## **DA 1034/2013 - Proposed 4 Storey Boarding House at 2-4 Glen Road, Ourimbah**

AUTHOR: Julie Garratley; Development Planner

### **SUMMARY**

**Figure 9:** The original south elevation to Glen Road is shown on the left, with the modified south elevation to Glen Road on the right. (Diagrams are not to scale)

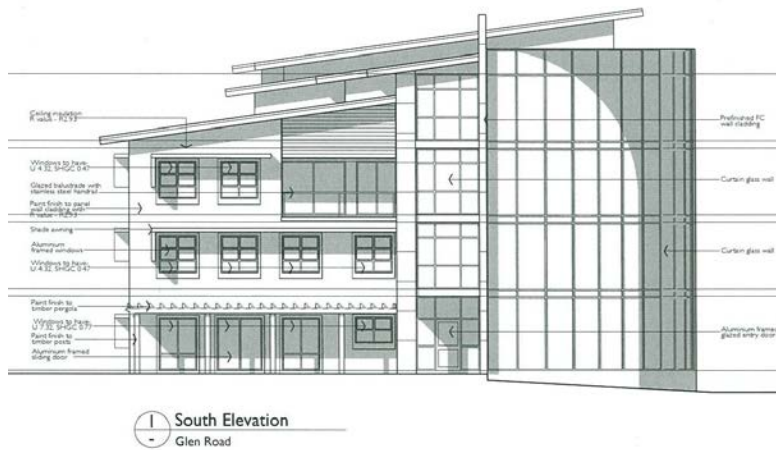
The original concept was considered to be an overdevelopment of the site in terms of bulk, scale, design and inconsistent with the objectives of SEPP 65. The applicant was requested to modify the design based on community feedback and assessment from relevant Council staff.

A modified proposal was submitted in March 2014 with the number of rooms reduced to 94 rooms, one manager's residence, associated carparking and open space areas. The height of the development was also reduced to incorporate a two storey façade that presented to the Glen Road frontage. The development then stepped up to 3 and 4 storeys to the rear of the site. The modified development includes the following:

The building was re-designed to reduce its bulk and scale and improve its presentation to both Glen Road and the Pacific Highway. The building presents as a two storey development at the Glen Road frontage with the third and fourth level setback from the previous edge in a stepped manner as shown in figures 10 to 16. External finishes and colours were also modified to reduce the visual mass of the building.

**Figure 16:** Shadow diagram showing projected shadows on 21 June. The 9am shadow is identified by the solid red line.

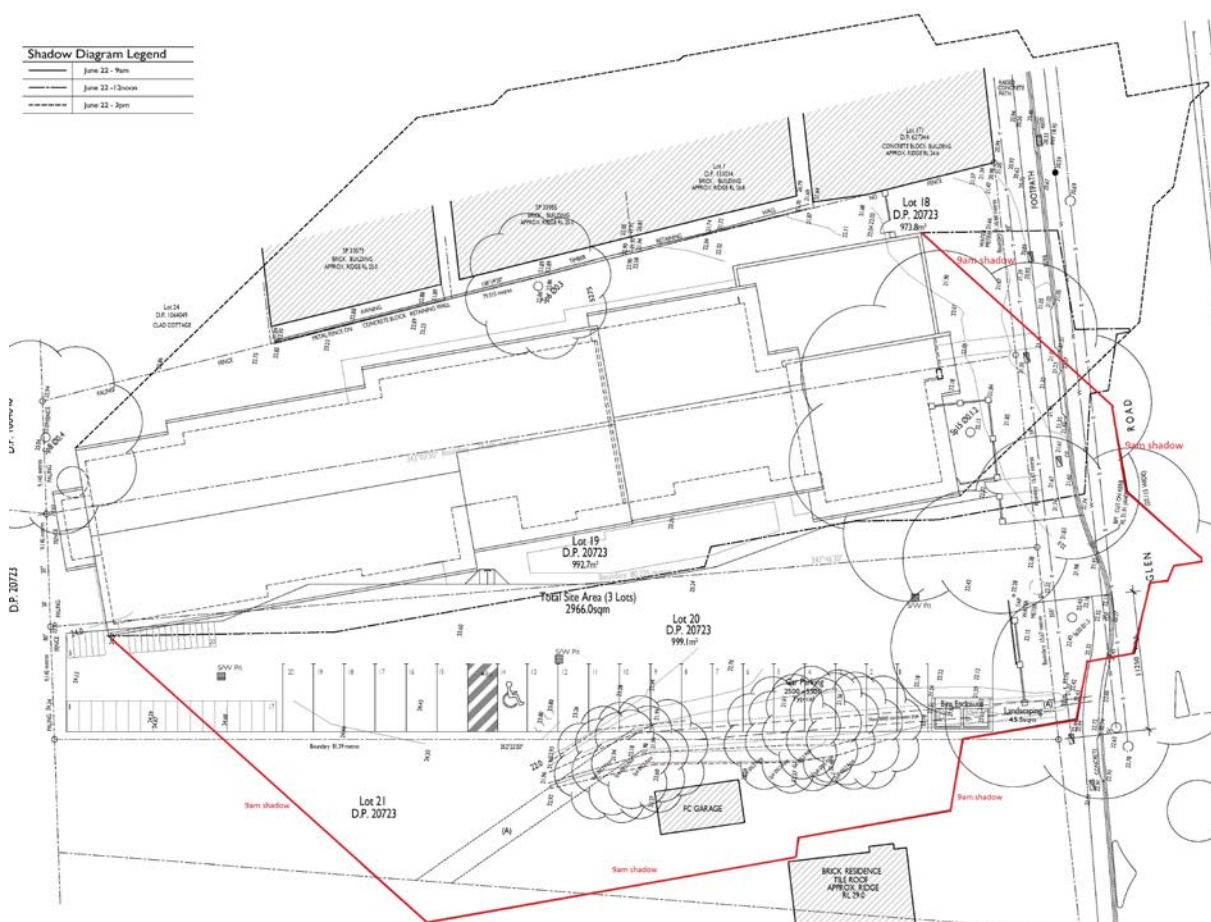
The development application included shadow diagrams which show the shadow impacts of at 21<sup>st</sup> June the winter solstice. The proposed development will project a morning shadow into the neighbouring property at No 8 Glen Road which will cover the existing garage but fall just short of the existing dwelling. The dwelling at No. 8 will therefore not be overshadowed at any part of the day by the proposed development between the hours of 9am and 3pm. The midday shadow will project to the kerb line of the road while the 3pm shadow will project to the shops adjacent to the east. The private open space of No 8 Glen Road will not be affected from 12 noon and through the remainder of the day (see shadow diagram below).

Therefore, the proposed building is not going to cause any unreasonable overshadowing on adjoining properties.
